From: Simon Davis
Sent: 04 February 2022 11:12
To: 'Sarah Sutcliffe' [REDACTED]
Cc: Chris Brake [REDACTED]
Subject: RE: AL/141/21/RES Lees Yard

Subject: AL/141/21/RES Lees Yard

Figure 14. Using batons to cover the fencing joins on an acoustic fence

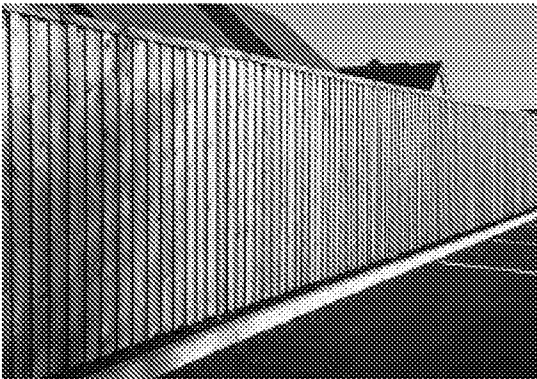
- Condition 5 of the outline requested that acoustic fencing be included in the RM submission. I note that this is referred to in the Compliance Statement (CS) but we need a specification of this. A separate layout plan showing all boundary treatments and then an accompanying specification/elevation for each type would be helpful.

Further to the below, in respect of your query on the acoustic fence and the detail requested, our technical team have drawn our attention to the the approved noise report as this is very detailed as to the specification/requirements stipulated.

Section 9.4 of the acoustic report states that the fence needs to be 2m high and should be constructed from butt jointed timbers (minimum of 20mm thick with 12 – 20mm cover strips over the butt joints as per the diagram below.
